1972 onwards Norton Commando Wiring Schematic + Pazon Sure-Fire Electronic Ignition

Grant Tiller February 2025

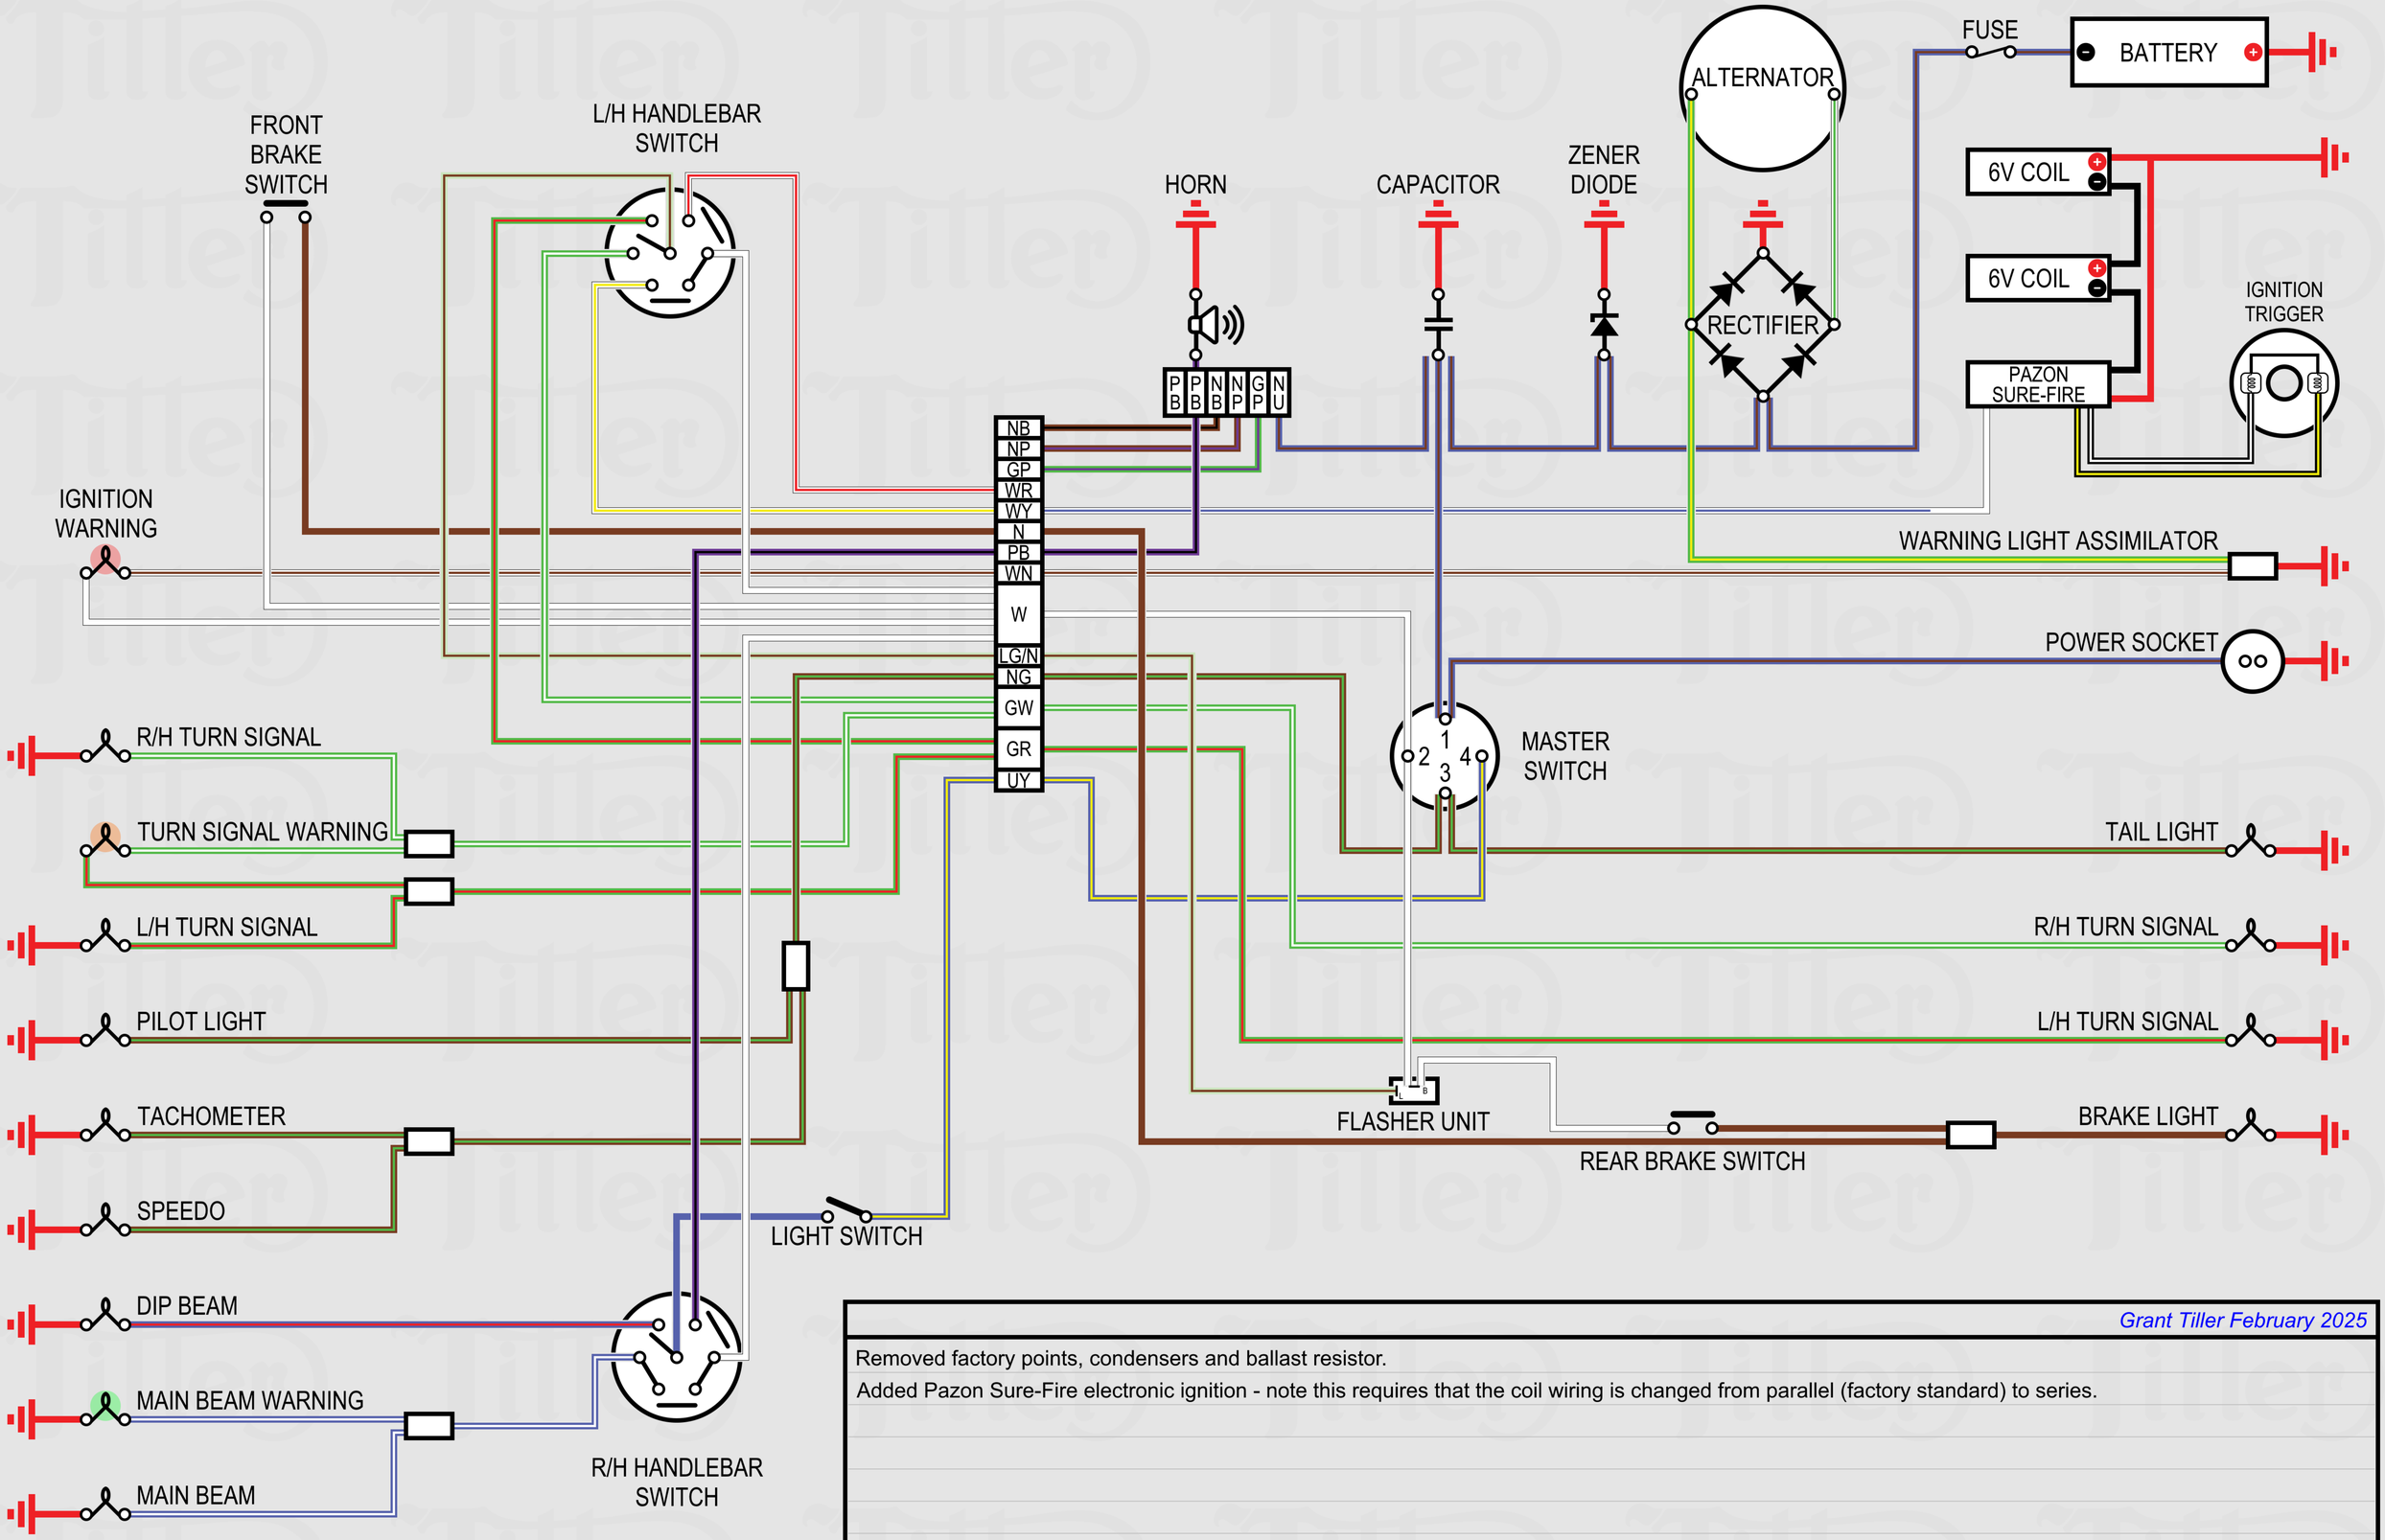
Removed factory points, condensers and ballast resistor.

Added Pazon Sure-Fire electronic ignition - note this requires that the coil wiring is changed from parallel (factory standard) to series.
